Vermont Agency of Transportation  
**RECEIVED**  
CK'D BY CLB OK'D BY HIS  
July 22, 2015  
RESUBMIT NO Approved  
BY C. CARLSON DATE 07/23/15

G.W. TATRO CONSTRUCTION, INC.  
VT/AOT BRIDGE REPLACEMENT - ROAD IMPROVEMENT  
RICHFORD, VT.

SHOP DRAWING F5  
C22312-F5

Quantity: 2 Project No: BRFO30229 SHEET 1.3 OF 14

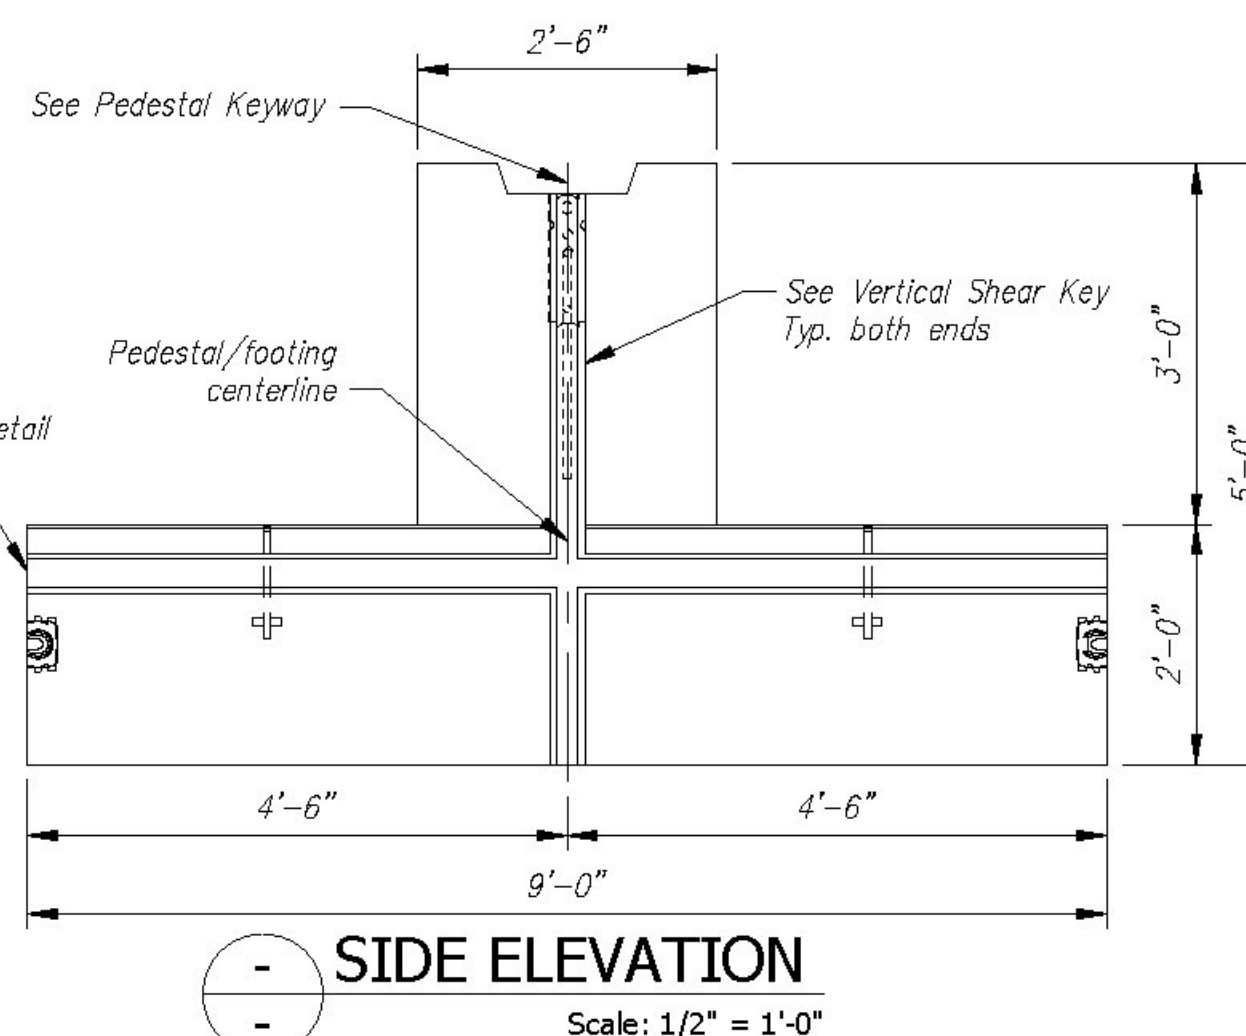
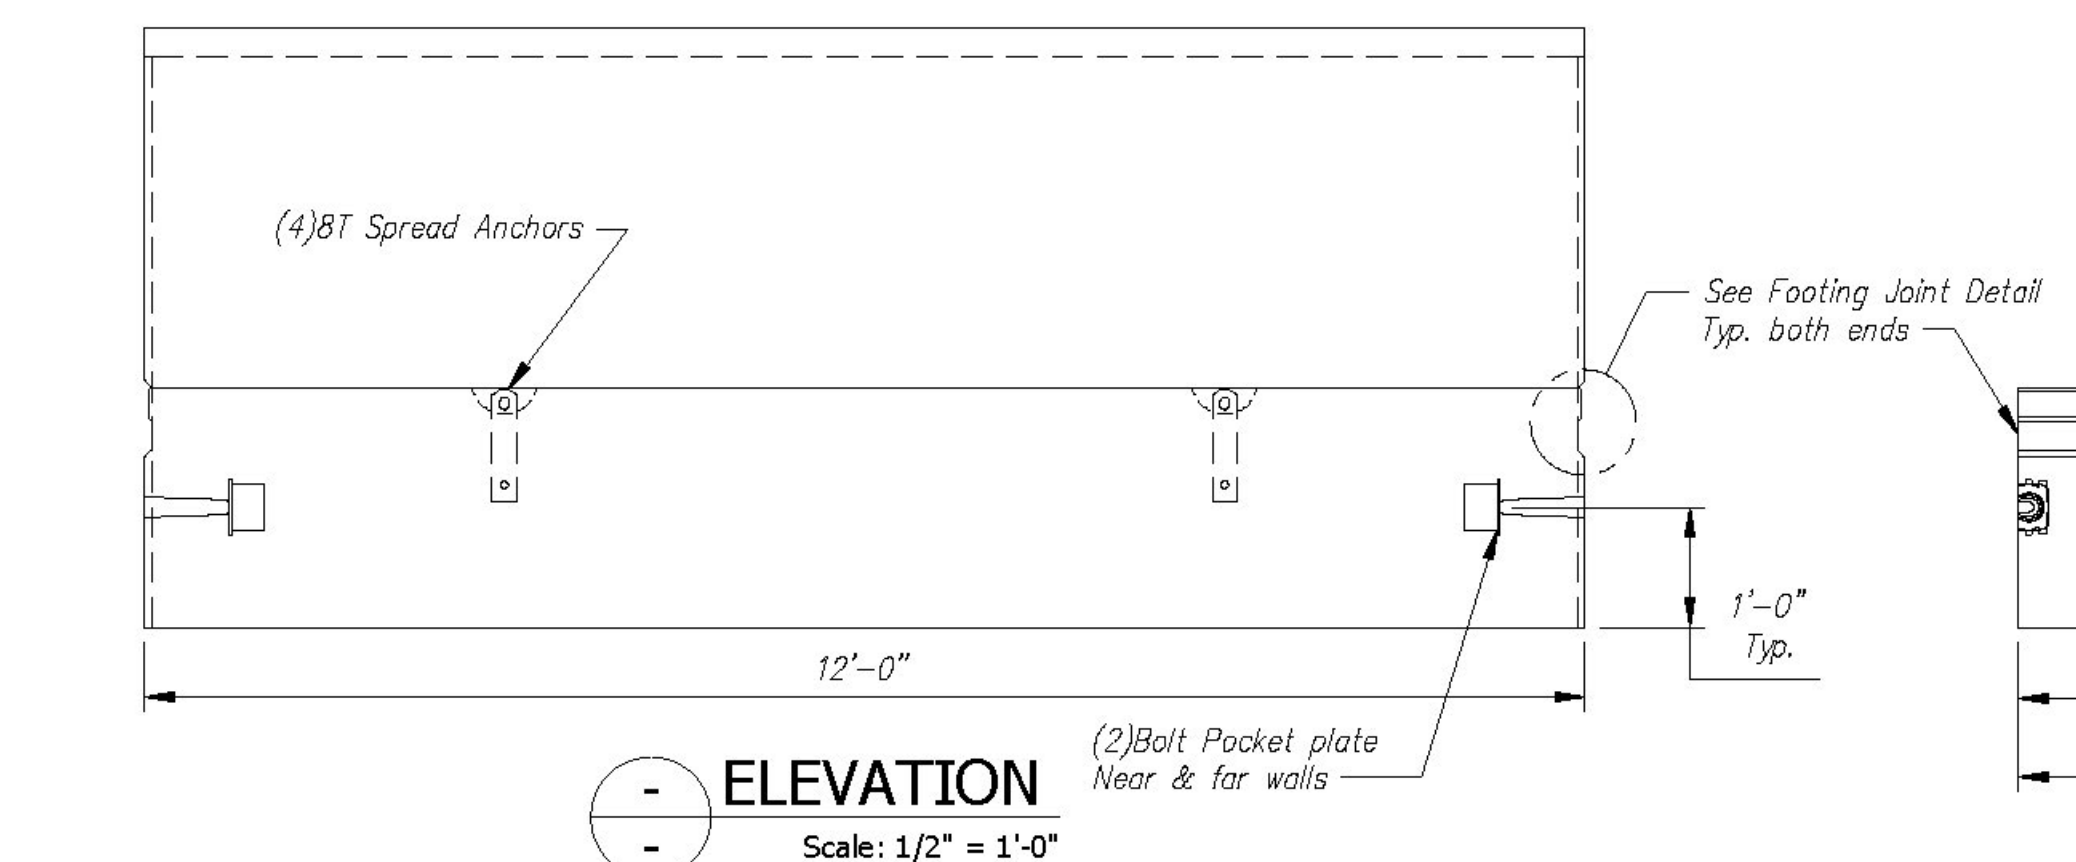
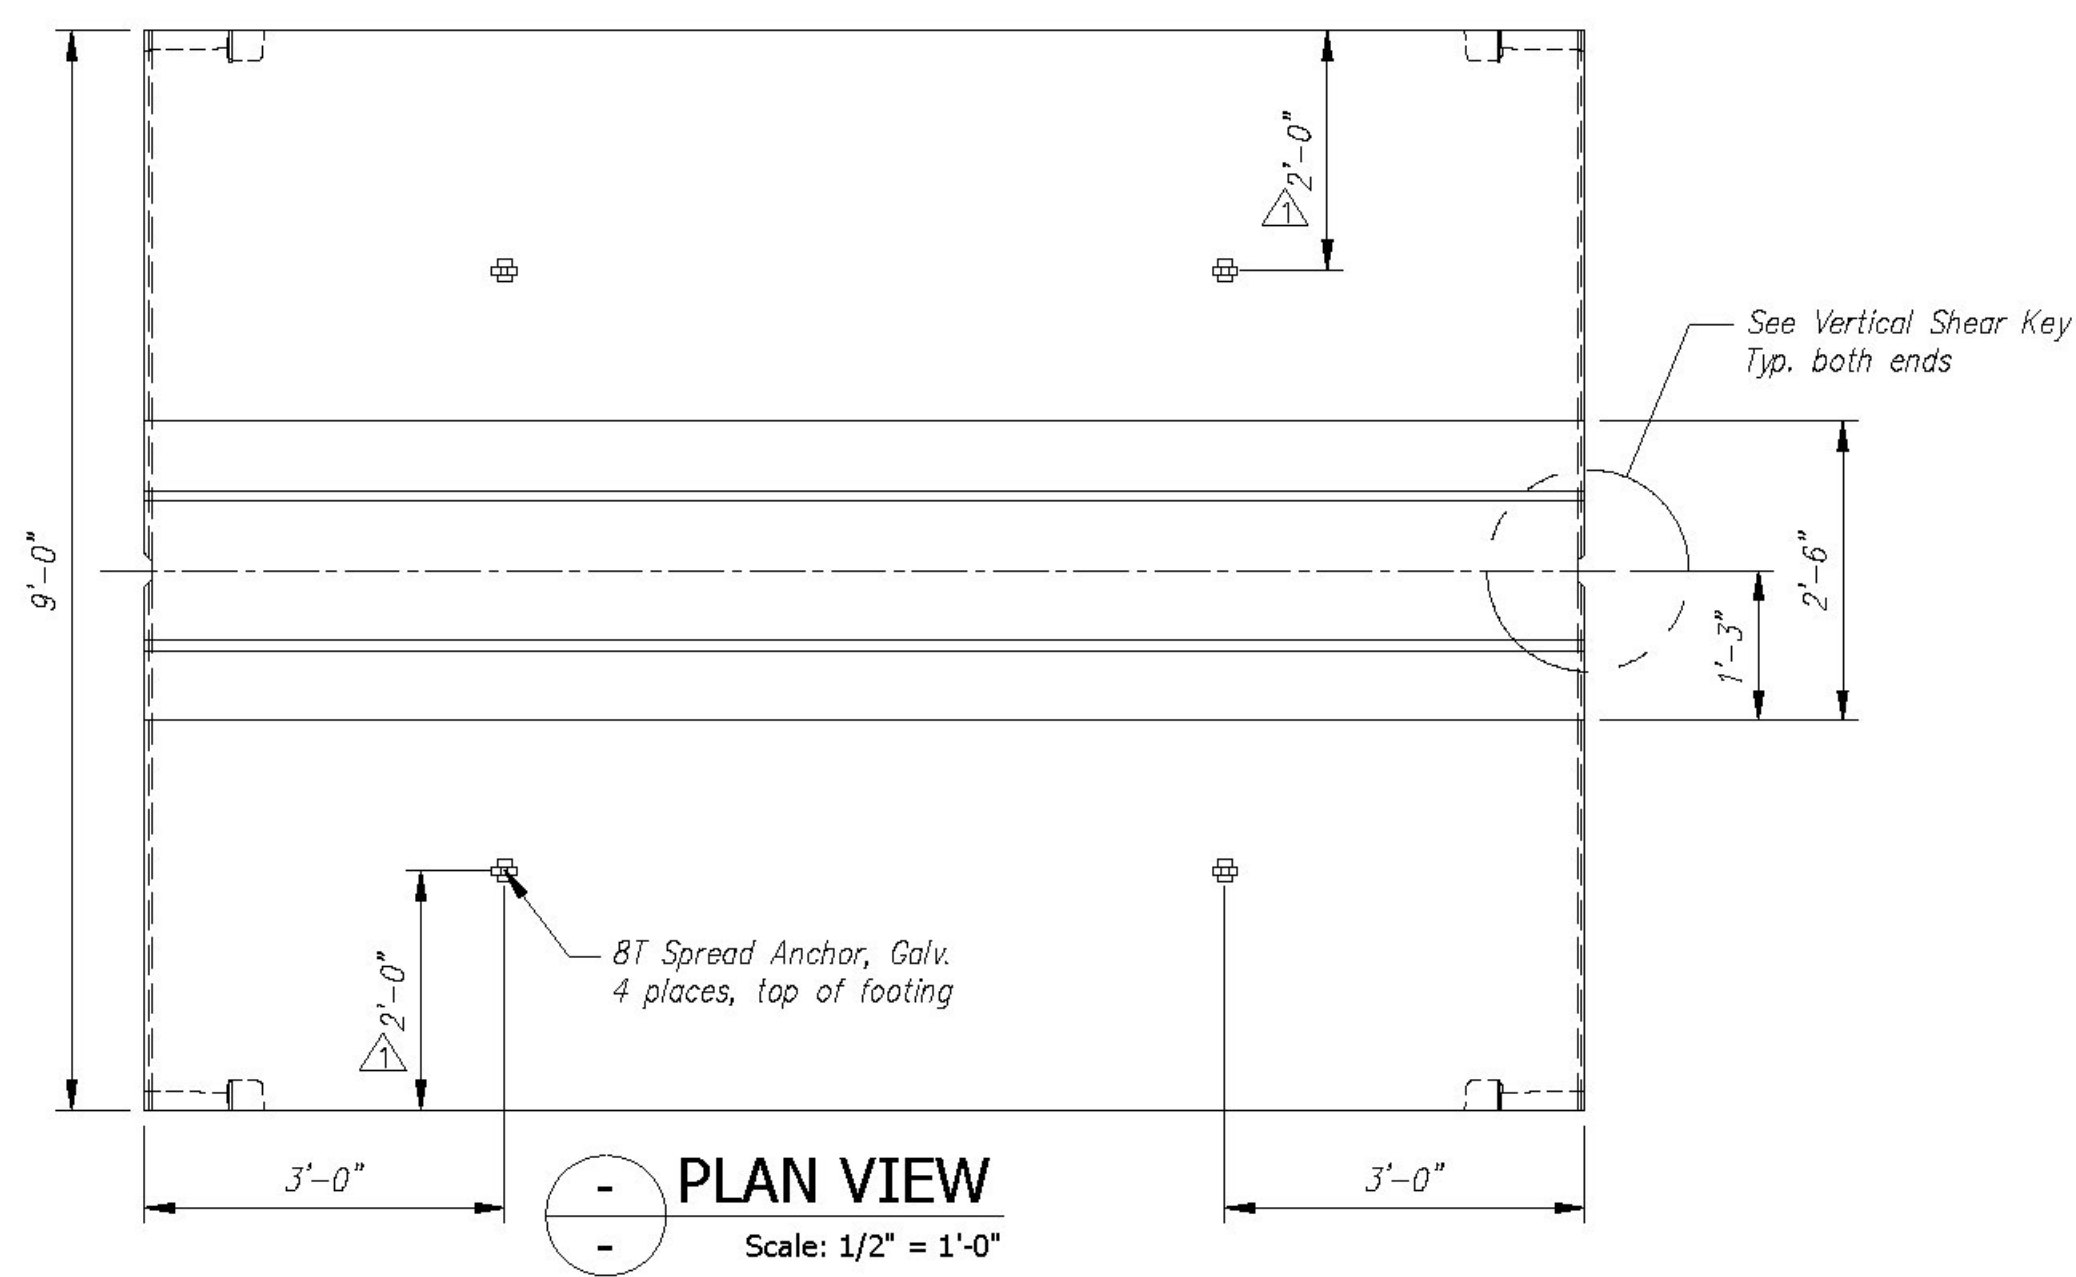
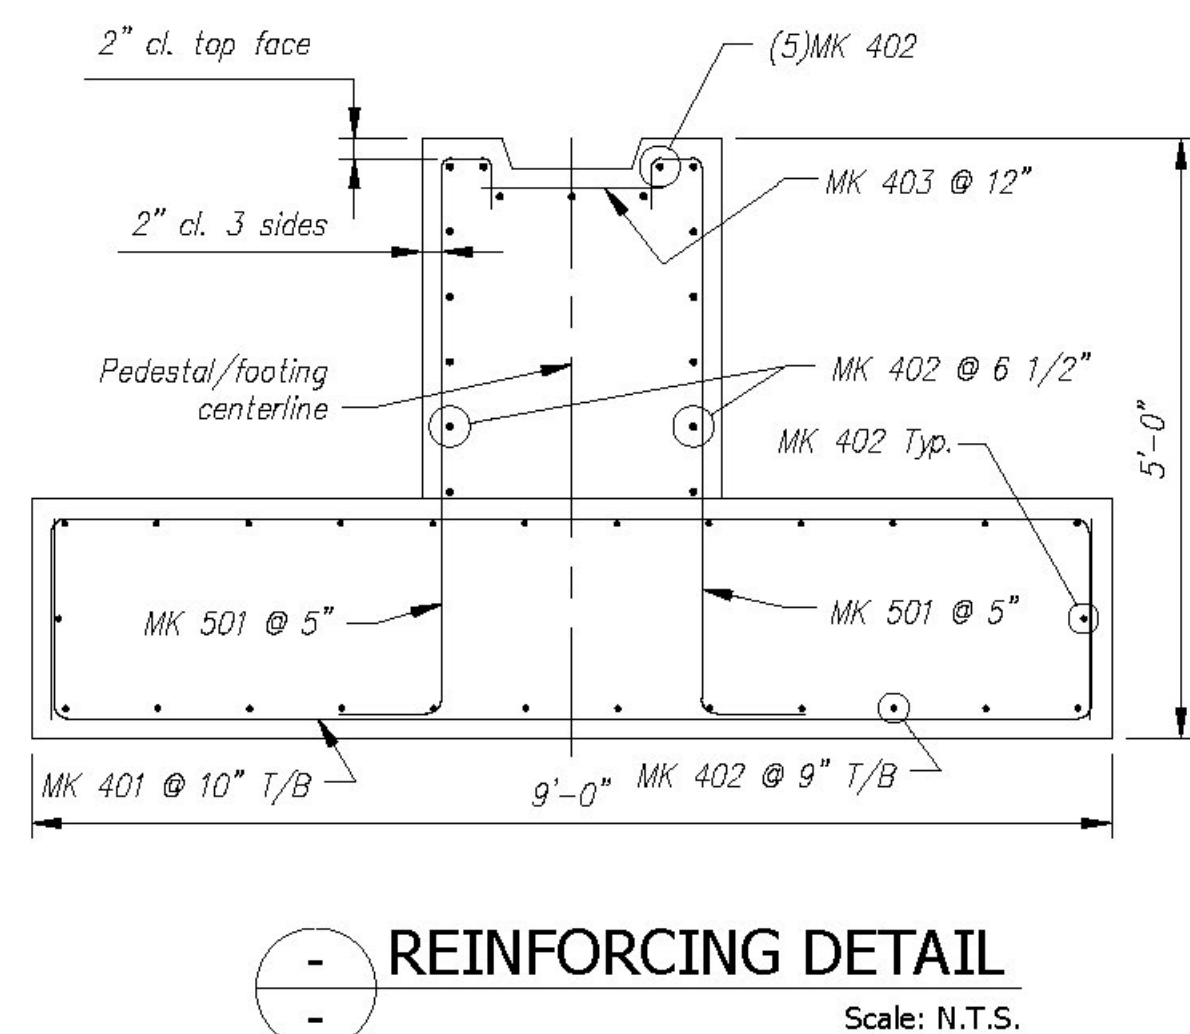
| Rev. | Date      | DESCRIPTION   | REVISIONS |
|------|-----------|---|-----------|
| 1    | 14MAY2015 | REVISED PER CUSTOMER REVIEW, REVISED ANCHOR LOCATIONS |           |
